To: Suchomel, Bruce[Suchomel.Bruce@epa.gov]
Cc: Nicole Colby[ncolby@pgei.com]
From: Mike Hackney
Sent: Tue 8/2/2016 2:20:35 AM
Subject: RE: Petroglyph Operating Arch. info

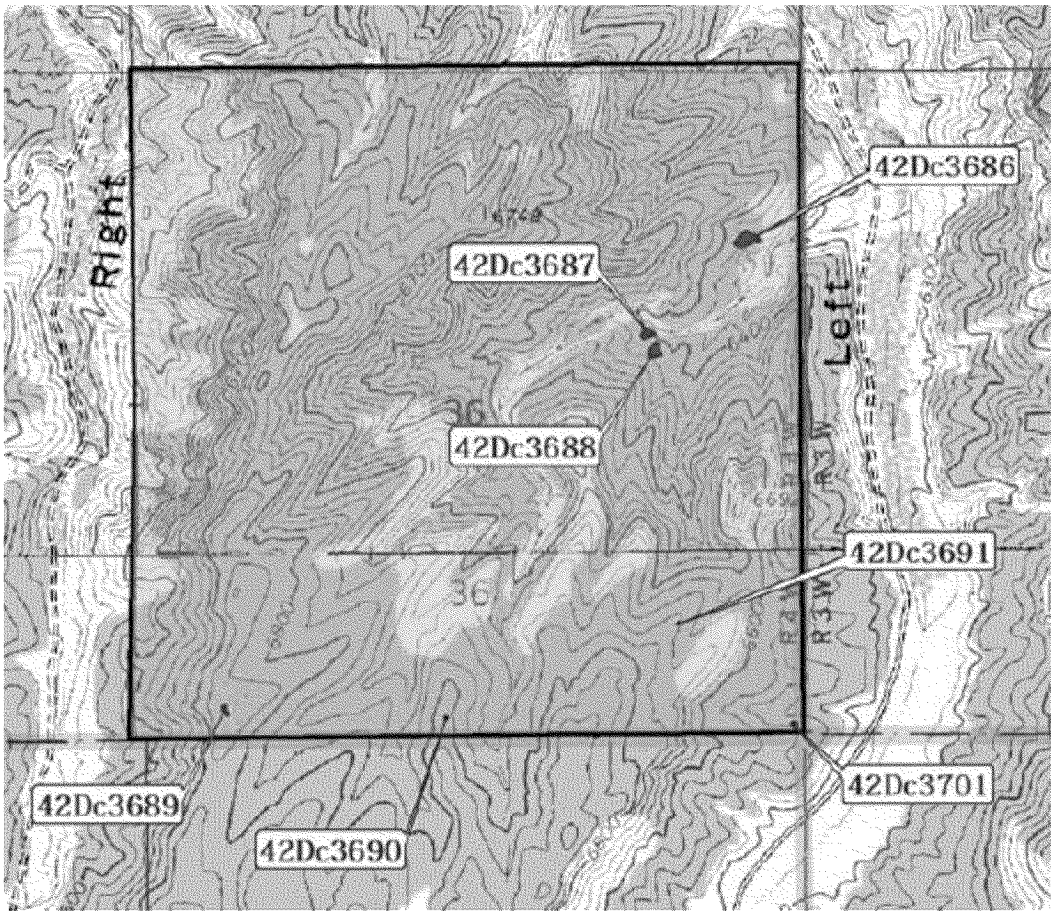
If your question is about the …3686 site that appears to straddle the road to the 36-08E4.

I'll still need 2 and 3 below – as we have strict consultation procedures. Also, the map shows four blobs, but seven areas are mentioned in the CRI. Is it possible that some blobs cover more than one CR?

If so, which ones and how many CRs per blob?

3. Here's the map from the CRI showing all the blobs (without buffers). All seven blobs are indicated.

I don't think you are reading the sentence in red as was intended. What it is saying is Tribal protocol requires that all sites eligible for the NRHP are to be avoided, but ALSO Native American sites that may not meet the standards of a NRHP designation. The …3701 site is such a site as described in in the CRI. So there are 5 sites that we are to avoid (and I count 5 blobs in section 36 on the map I forwarded). The other two sites are of European-American origin.

1. The maps provided are not intended to be precise locator maps to keep the public away from relic hunting

2. The road dates from 1998 and predates the CRI by 16 years

3. An Archeological survey was prepared in 1997 (as mentioned in the CRI you have)

4. The site in question consists of some sharpened rocks. It's entirely possible that the 1997 Arch survey simply missed it.

5. If the road actually does go through an Arch site, there's nothing that can be done about that now.

1. Allow the pipeline to be buried on the uphill side of the road because the cultural site isn't really where shown

2. Allow the pipeline to be buried in the middle of the road near the site since that would result in no new disturbance, but likely only if doing so would not cause erosion in the road.

3. Allow a pipeline to be placed cross-country away from the road and arch sites

4. Deny the pipeline right-of-way
